Vermont Agency of Transportation
RECEIVED
CK'D BY D. PETERSON OK'D BY C. CARLSON
June 1, 2015
RESUBMIT YES Rejected
BY C. CARLSON DATE 06/12/2015

# 2 RAIL BRIDGE RAIL TO GUARDRAIL TRANSITION

PROJECT: ANDOVER BHF 016-1 (29) VT RTE11, RURAL MINOR ARTERIAL, BRIDGE NO. 41
TOWN OF ANDOVER, WINDSOR COUNTY, VERMONT

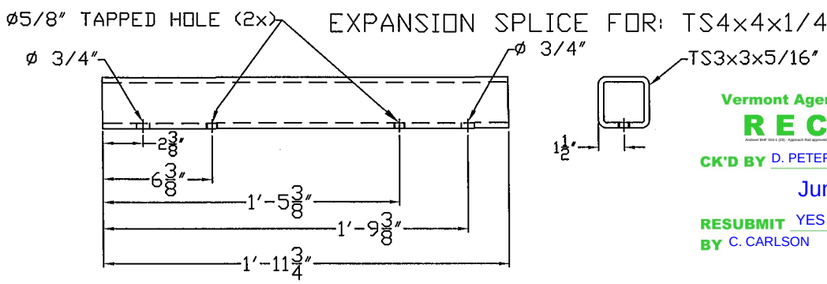
A 449 (TYPE1)
ROUND HEAD BOLT
ONLY FULL DIA. BOLTS WILL BE ALLOWED

EXPANSION SPLICE FOR: TS8x4x5/16"

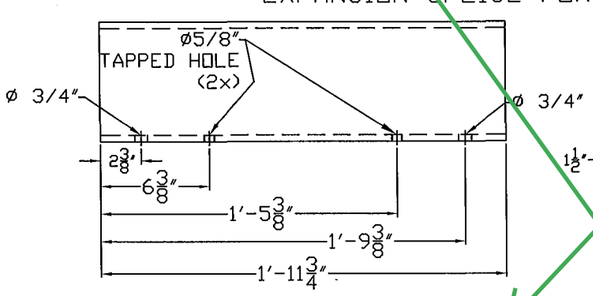
Splice is angled down off the bridge. These bars may need to be bent to fit.
